## ORIGINATION FORM

### Proposed Revisions to a Standard Plans Index

Index Number: 455-054  
Sheet Number (s): 1  
Index Title: 54" Precast/Post-Tensioned Concrete  
Cylinder Pile

ELEVATION

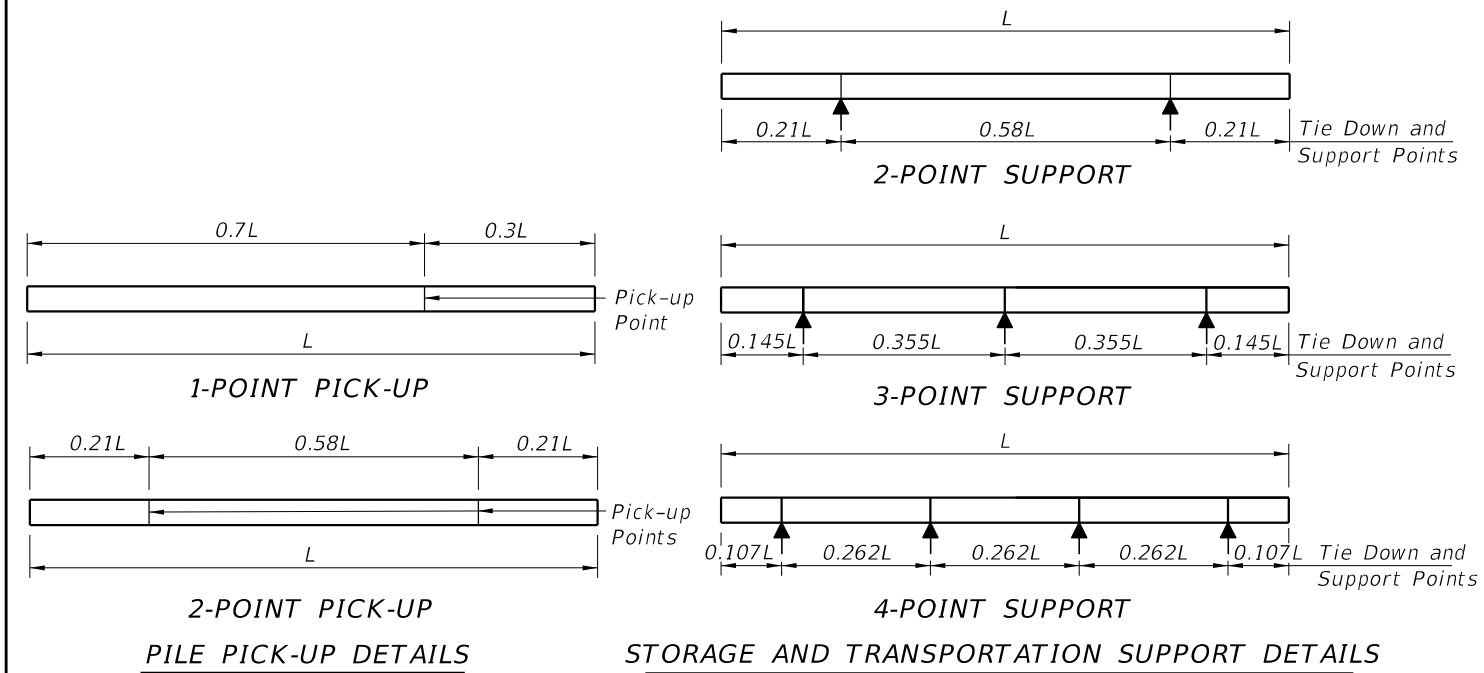
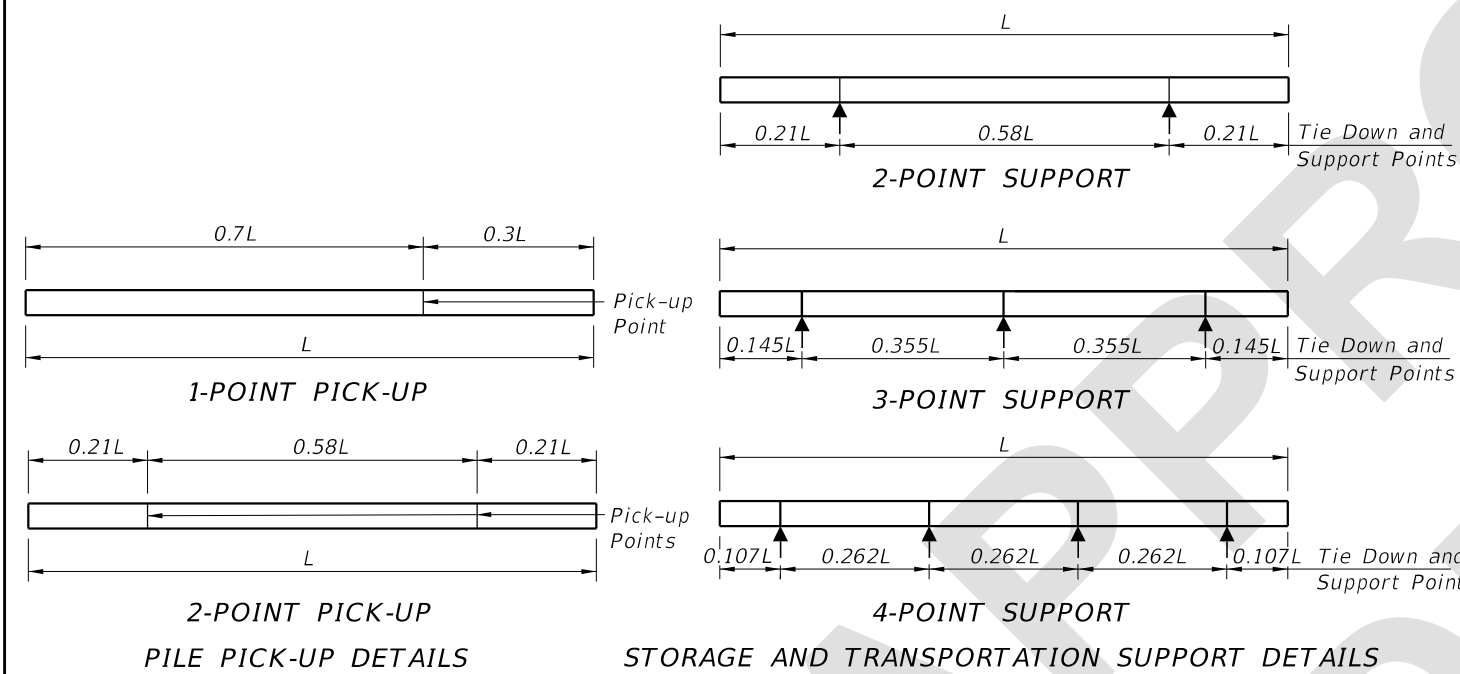
Changed Class V (Special) concrete to Class V.

- Work this Index with the Pile Data Table in the Structures Plans.
- Concrete:
  - Piles: Class V ~~(Special)~~
  - Splice: Class IV.
  - See "GENERAL NOTES" in Structures Plans for locations where the use of Highly Reactive Pozzolans is required.

1. Work this Index with the Pile Data Table in the Structures Plans.
2. Concrete:
  - A. Piles: Class V.
  - B. Splice: Class IV.
  - C. See "GENERAL NOTES" in Structures Plans for locations where the use of Highly Reactive Pozzolans is required.
